BAR Meeting  
October 15, 2014

**ISSUE:** Partial Demolition/Capsulation and Certificate of Appropriateness for Alterations

**LOCATION:** 115 Queen Street

**BAR2014-00290 & BAR2014-00291**

SOUTH ELEVATION - PROPOSED

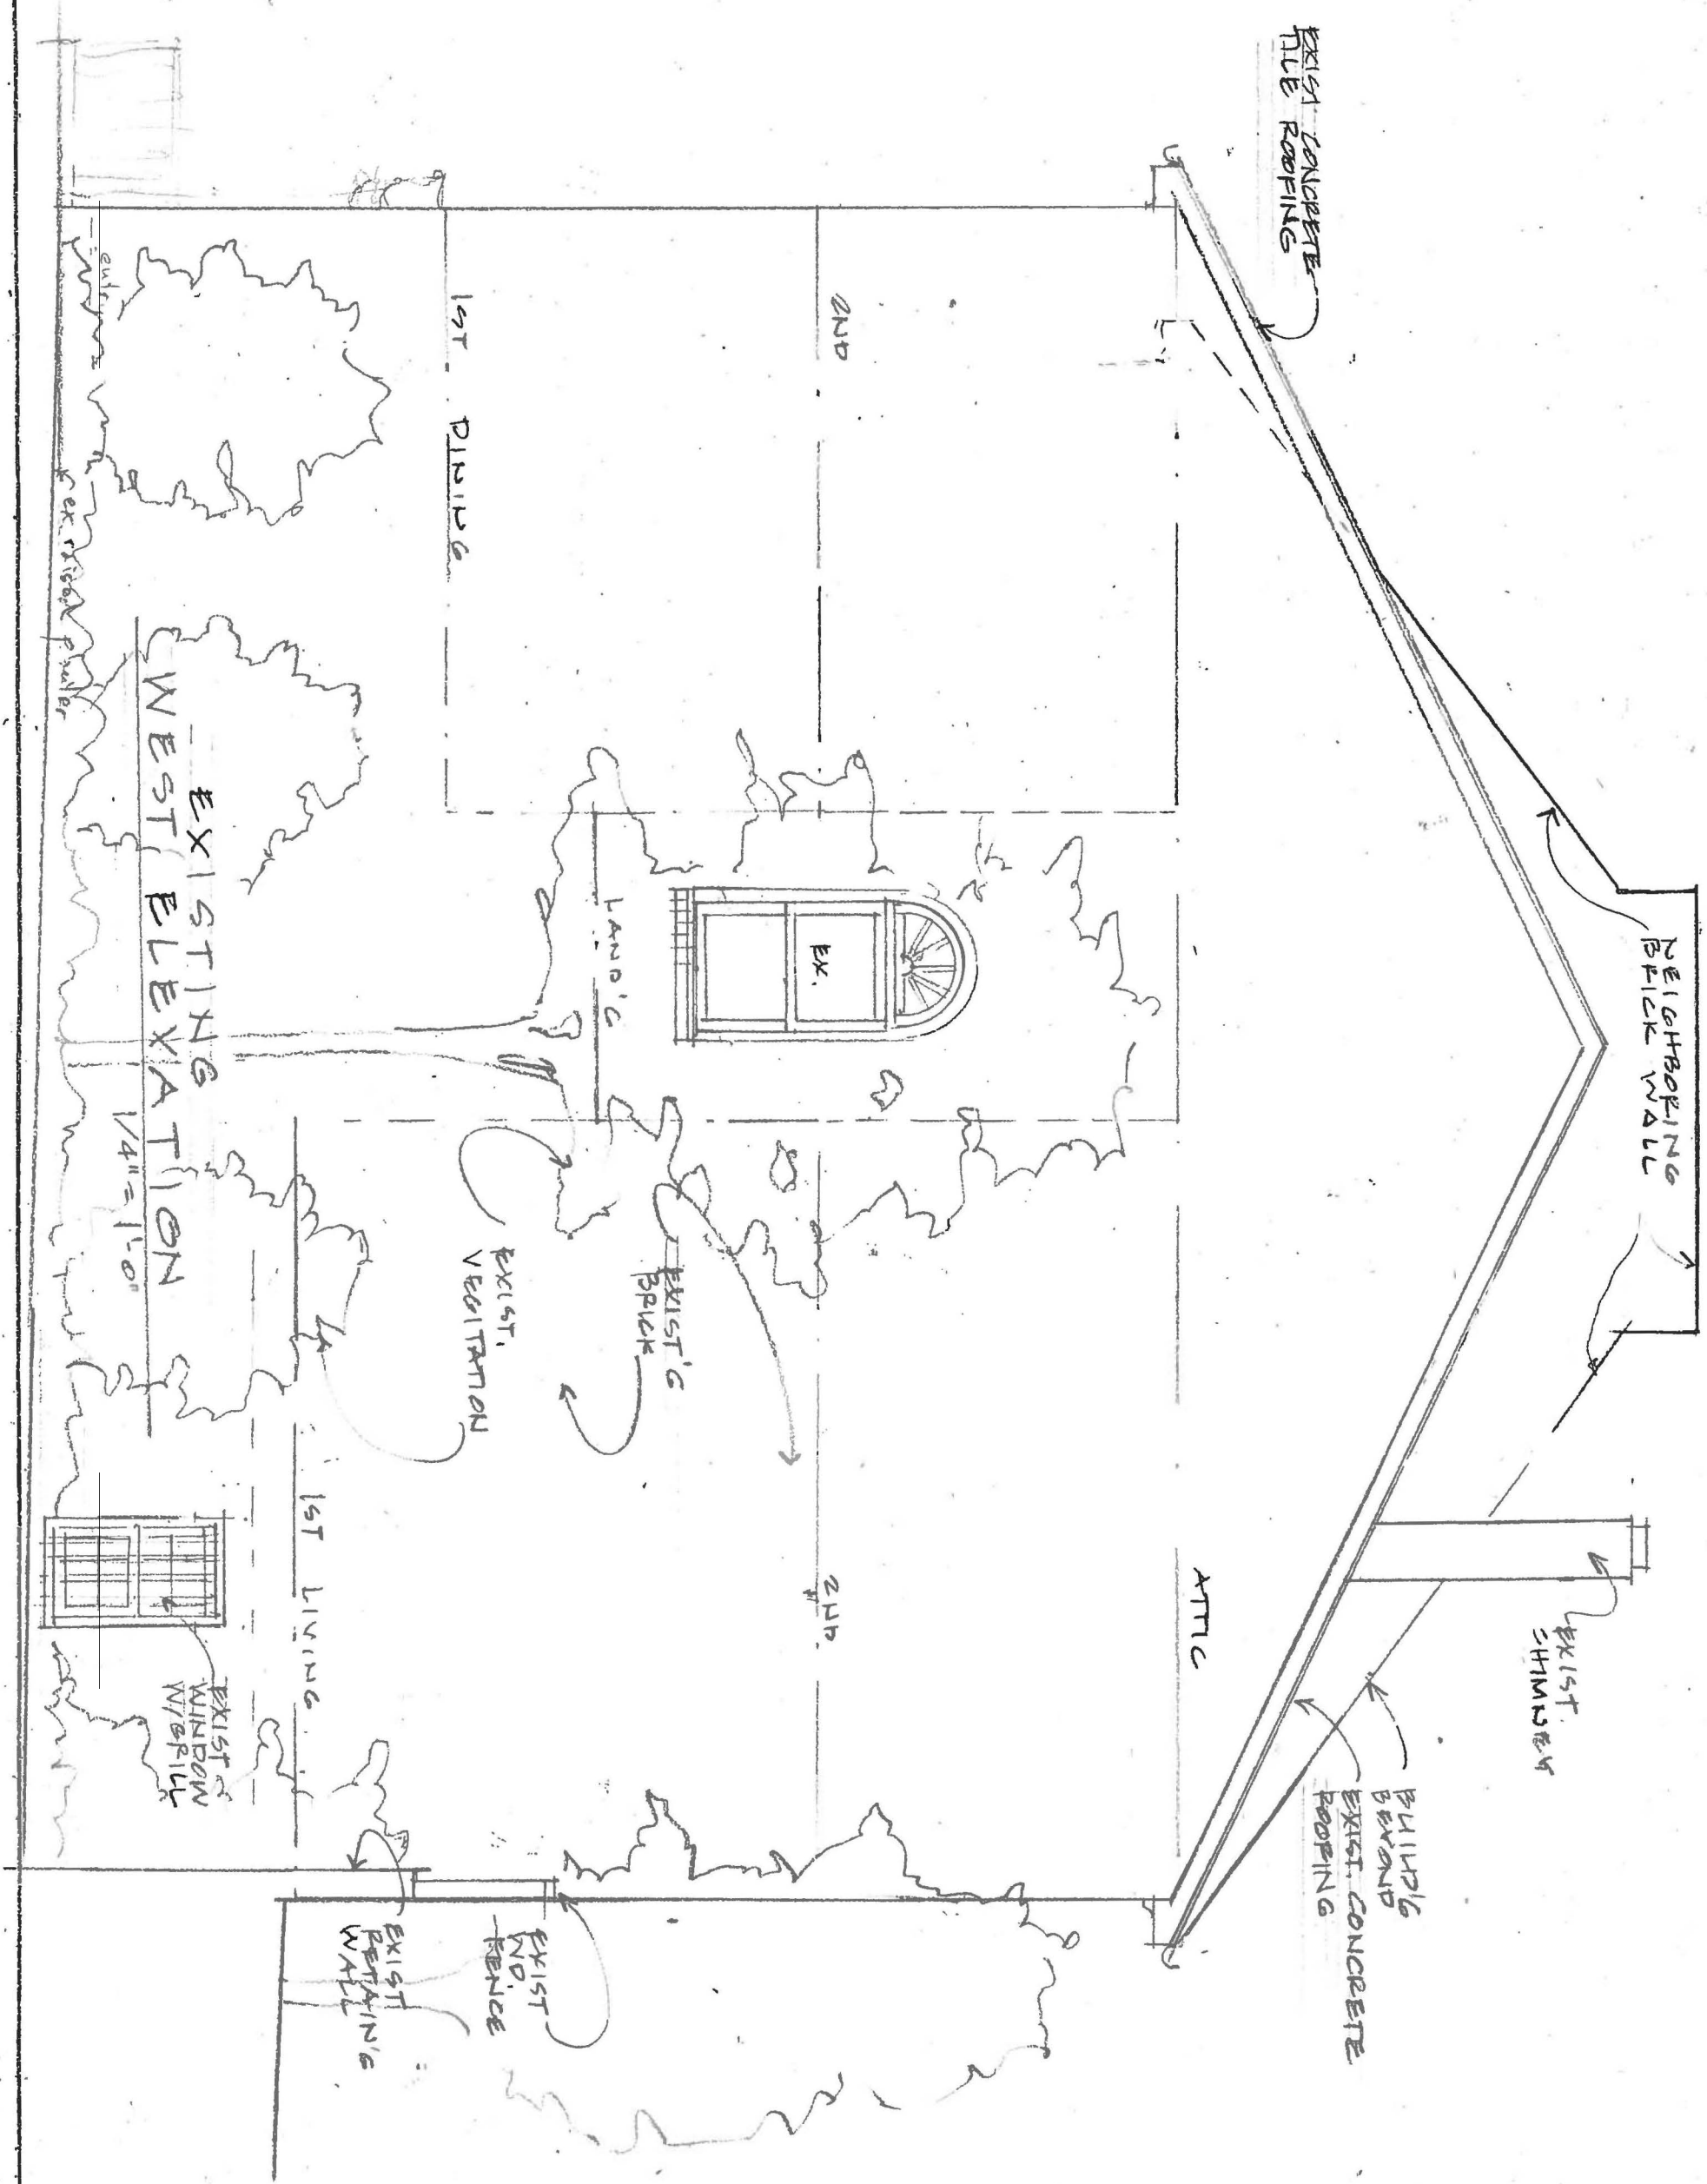
The proposed replacement garage door is very similar to the existing and could be approved administratively by staff under the *BAR Minor Architectural Elements Policy*. The proposed cornice above the garage, however, is an alteration that requires Board approval. Staff supports the cornice, as it matches the design of the existing door hood. Staff recommends a wood or high quality, paintable, millable and solid-thru-the-core synthetic material, as the Board has previously stated that high quality modern materials are acceptable on later structures.

1. That the applicant work with staff to accurately determine the existing roof material, with staff approval of the replacement in compliance with the *BAR Roof Policy*;
2. That the skylight flashing matches the color of the roofing;
3. That the skylights have integral shades;
4. That the windows comply with the *BAR Window Policy* Performance Specifications, with final approval by staff during building permit review and;
5. That the cornice above the garage be either wood or a high-quality, paintable, solid-through-the-core composite.

# Fixed skylights

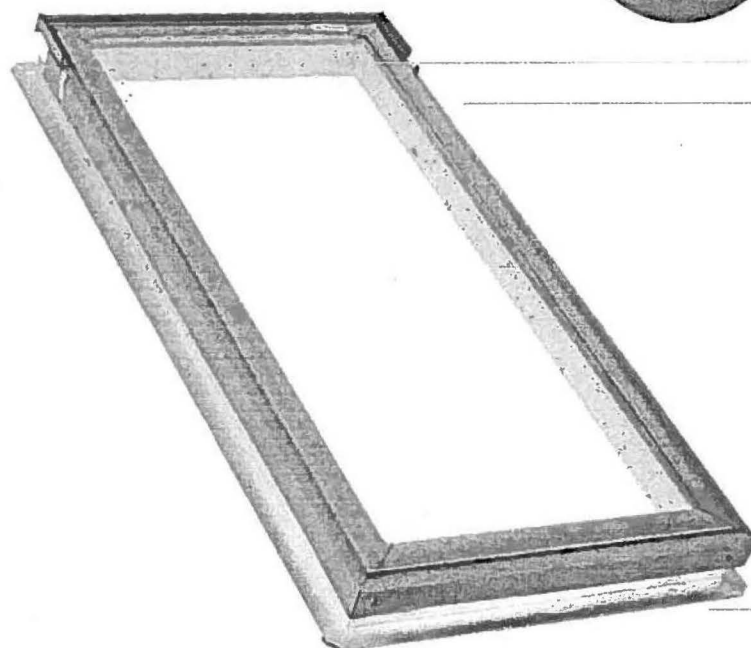
The *Design Guidelines* state that skylights should be located on the least visible location of the roof and should have integral shades to reduce the seepage of light at nighttime. Further, the guidelines recommend that the flashing should match the color of the roof covering. Staff finds that the location and low-profile of the skylights is appropriate, with the condition that the flashing matches the color of the roofing and the applicant install integral shades.

SHINGLE COLOR TO BE  
OYSTER GRAY

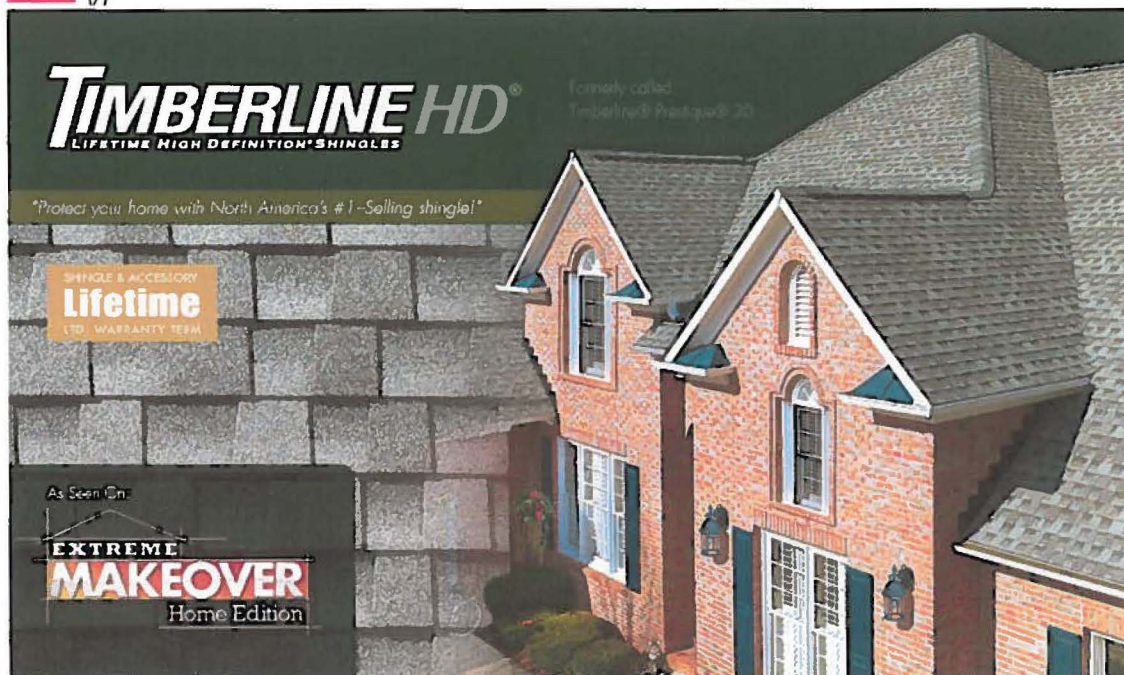
As a general policy, the Board discourages the use of asphalt or fiberglass shingles for roofing material, although the *Design Guidelines* state that fiberglass and asphalt shingles are appropriate on late 20<sup>th</sup> century structures. The *BAR Roof Policy* permits architectural grade composition roofing when it replaces original composition roofing, such as fancy-cut asphalt shingles used in the early 20<sup>th</sup> century. The policy also permits architectural grade composition roofing as a replacement for a Supra-Slate type simulated slate or other cement-asbestos roofing tile products on buildings constructed after 1975 and not located on the George Washington Memorial Parkway. The policy does not, however, permit replacement of authentic slate with composition shingles.

There is some question as to whether or not the existing roof material on the subject property is authentic slate or a composite tile, as both were used in this development. Therefore staff recommends that the applicant work with staff to determine the actual material and that the roof be replaced in accordance with the *BAR Roof Policy*, meaning that if the roof material is a

cement-asbestos product, architectural grade composition shingles can be used. However, if the roof is true slate, the applicant must replace with authentic slate in a matching color and pattern.
